RE: SES Solar One Project
Applicant's Responses to the CEC Memo Regarding Transmission Line Upgrades

SES Solar One
Response to CEC Memorandum
Docketed 12/8/2009
08-AFC-13

TECHNICAL AREA: TRANSMISSION LINE UPGRADES

**SLOPE
SOLAR 1
SCE TRANSMISSION LINE UPGRADES**

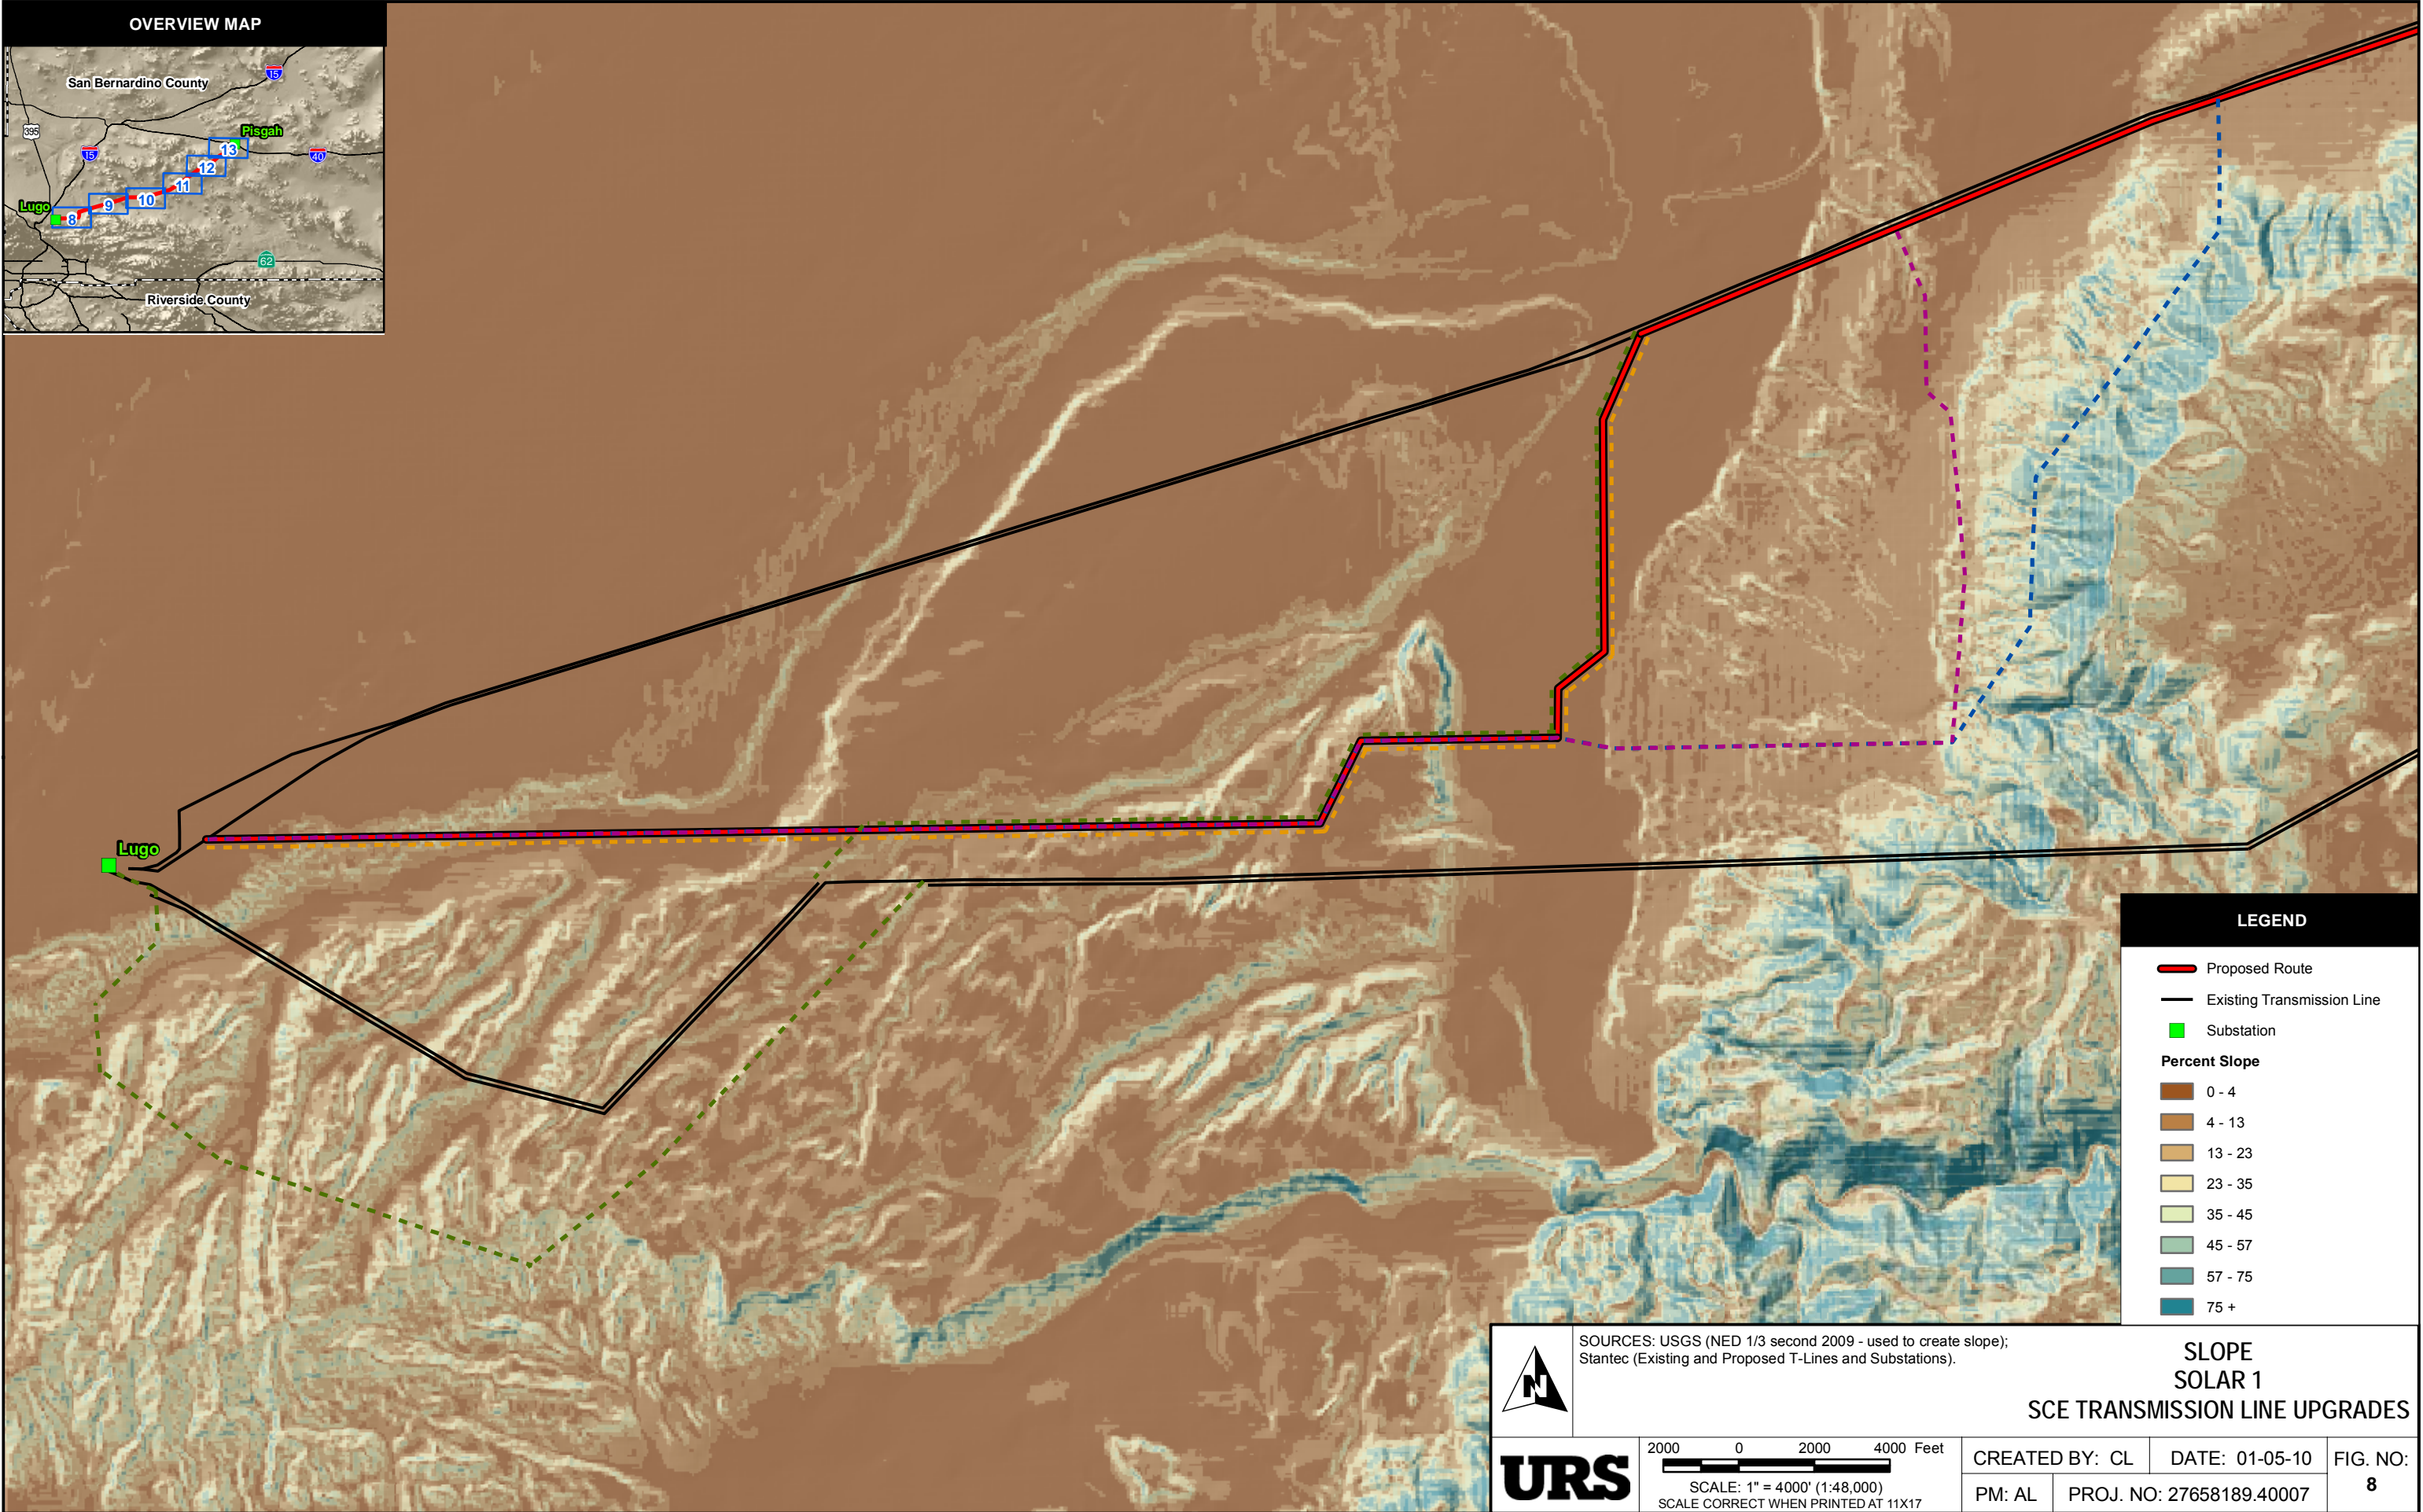
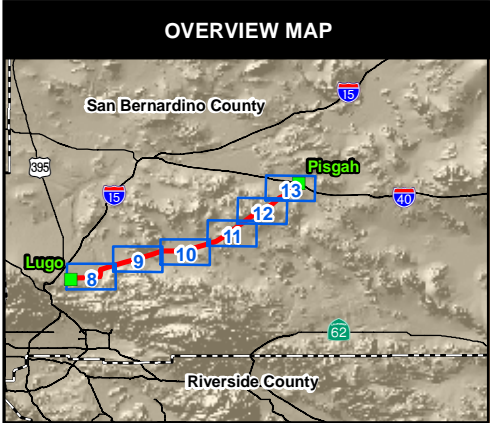
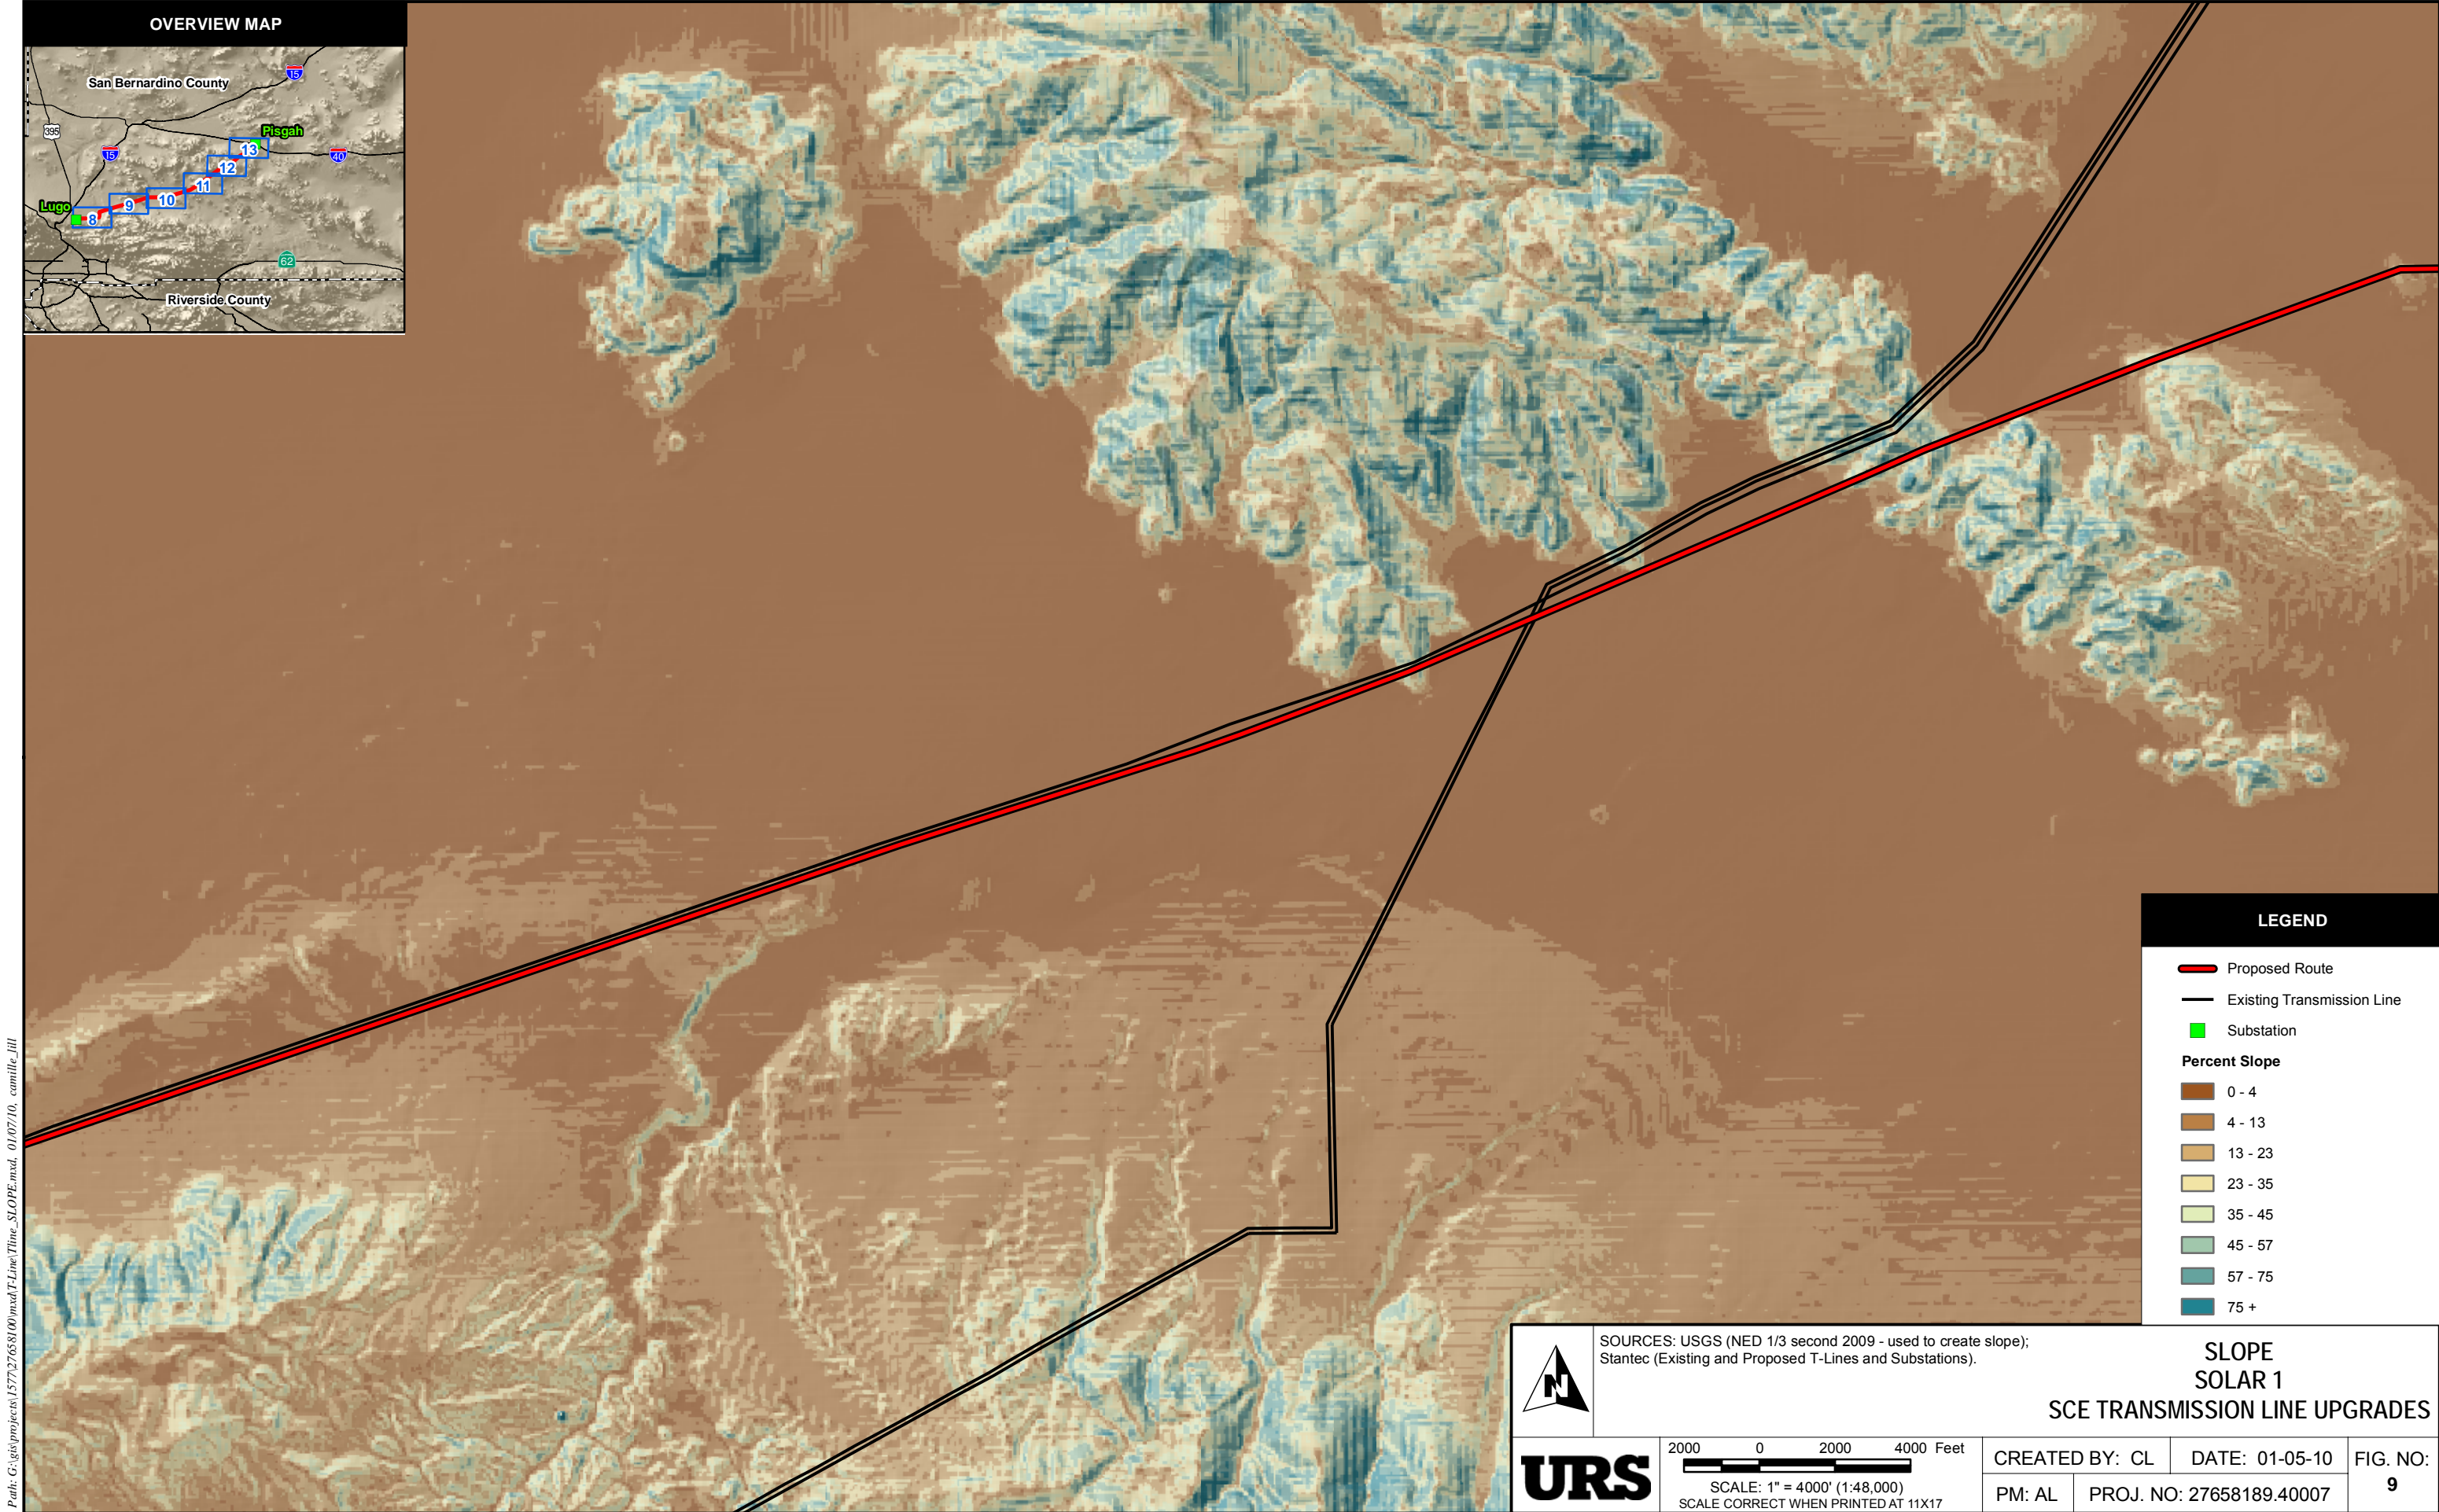
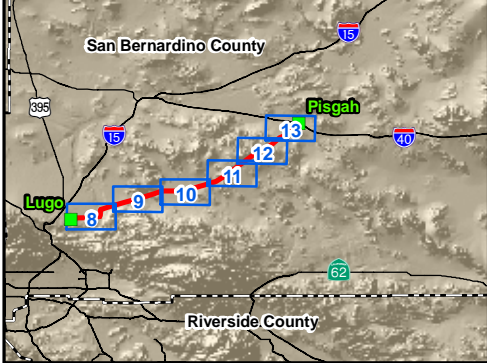
Item 10: Provide the slope gradients traversed by the alignments of transmission line upgrades and roads.

Response: Slope gradients for the proposed alignments (as shown in the AFC) and roads are depicted in attachment TRANS-5.
